Duplexes

**CITY OF PORTLAND, MAINE
DEVELOPMENT REVIEW APPLICATION
PLANNING DEPARTMENT PROCESSING FORM**

PLANNING BOARD REPORT #40-97

**MITTON STREET DUPLEXES
SITE PLAN AND SUBDIVISION REVIEW
WARD GRAFFAM, JR., APPLICANT**

PUBLIC WORKS I
MEMORANDUM

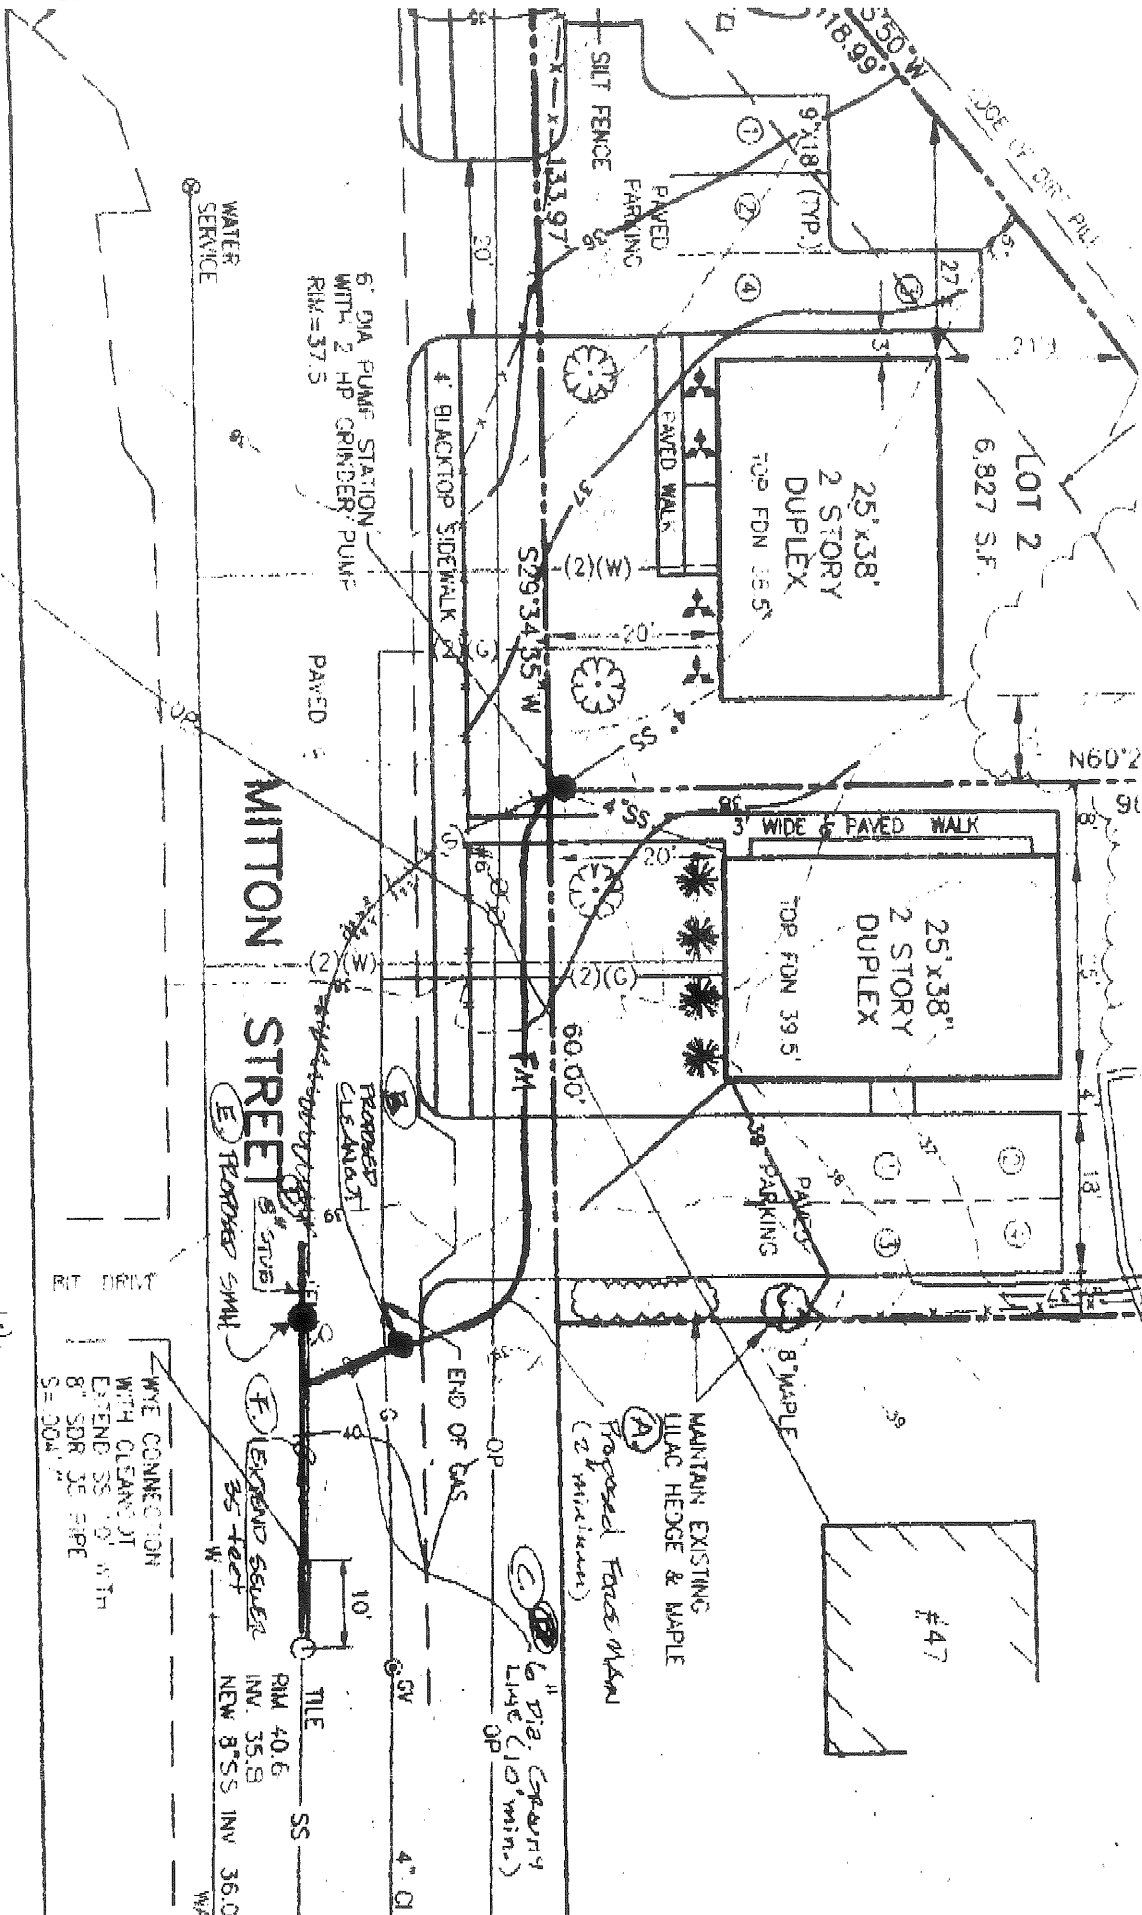
The following comments were generated during Public Works Engineering review of proposed duplex development on Mitton Street and the plans dated September 26, 1997. I have prepared a marked copy of the proposed "Subdivision Plan" designating the required design revisions with the letters A through F. A copy of this mark-up is attached.

- A. Install the proposed 2" sanitary force main in the esplanade as shown on the attached plan.
- B. Install a cleanout which will serve as a terminus manhole for the proposed sanitary force main.

- E. Install a type "A" sewer manhole as shown on the attached plan.
- F. Public Works is requiring an extension of the existing sanitary sewer main in Mitton Street, approximately (35) thirty-five linear feet beyond the existing sewer manhole. This extension should be made with 8" Dia. SDR 35 PVC pipe.

LEFT SIDE ELEVATION

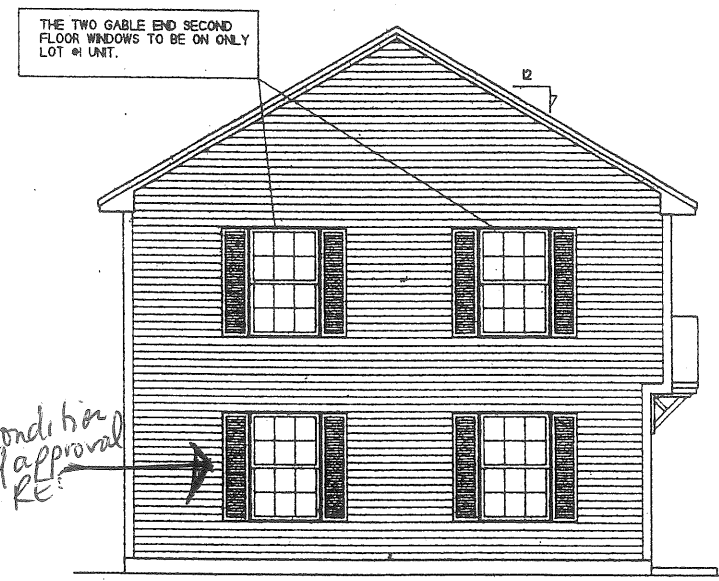
- that the Lot 1 left side (Mitton Street) elevation be revised by replacing the first floor, left side window with the rear door.

condition of approval RE: [arrow pointing to window]

Attachment 8

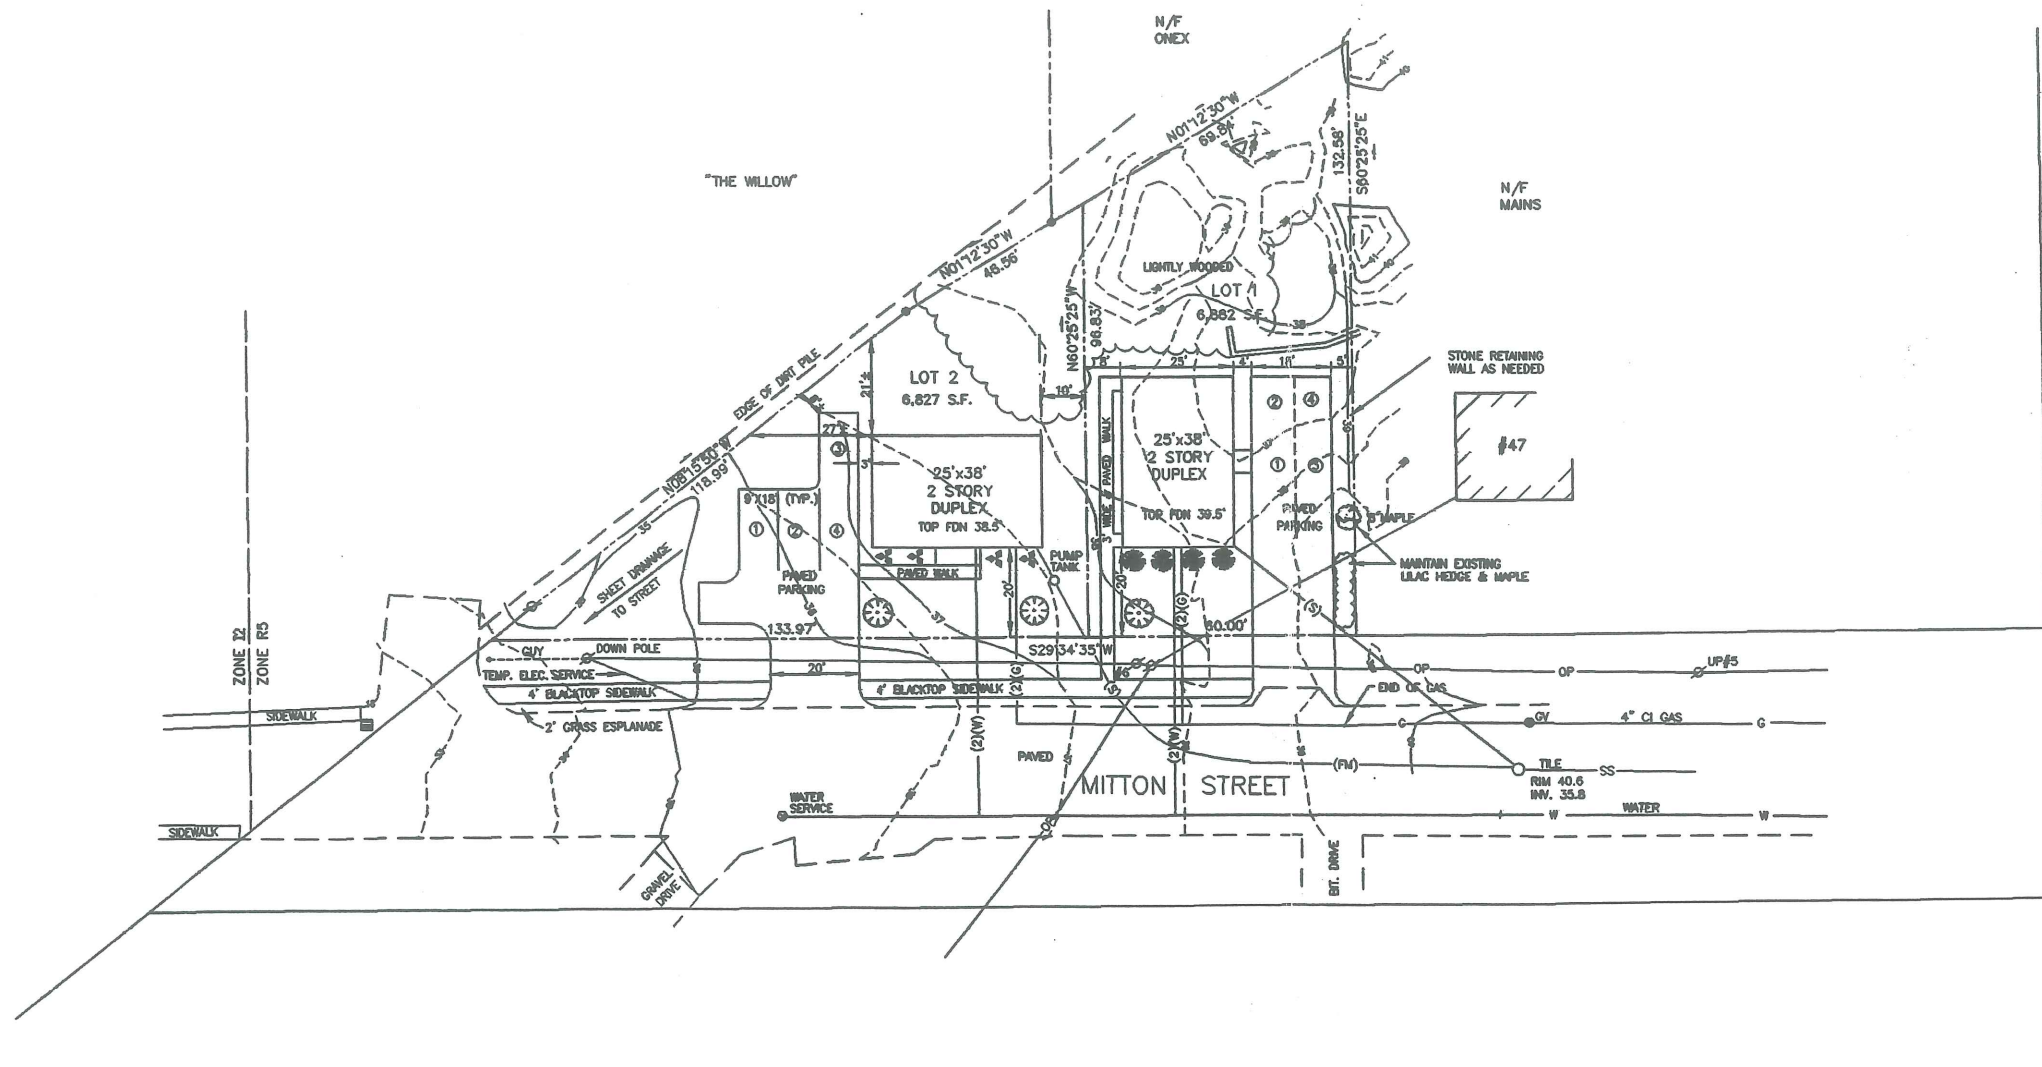
1. Recommend that a 15' drainage easement be established along the back property line in lot 2 with rights to use the easement by an owner in lot 1. This easement will allow the owner of lot 2 to fill the large low spot in the back yard and still be able to grade within the easement to provide drainage from the abutters.

2. Recommend that the low area within lot 1 be marked on the subdivision plat with a suggested note as follows: "No filling of this area is allowed without site plan approval by the Planning Department of the City of Portland". Recommend that this language be included in the deed for lot 1 as well.

3. Recommend that the deeds for each lot incorporating items 1 and 2 above be reviewed and approved before the Board takes final action.
4. Recommend that the elevation of the sidewalk be located per the typical section for a minor residential street; i.e. 4' esplanade from a future curb line and 7" above the future gutter grade.

5. Recommend that the curb cuts conform to Portland standards.
6. A detail for the "possible stone wall" is needed.
7. Will power, telephone and cable TV be underground? If so than the plan should show them.

8. The sewer services should be revised per Public Works comments.
9. Recommend that the roof drainage be directed away from the low spot in lot 1.
10. An erosion control management plan is required.
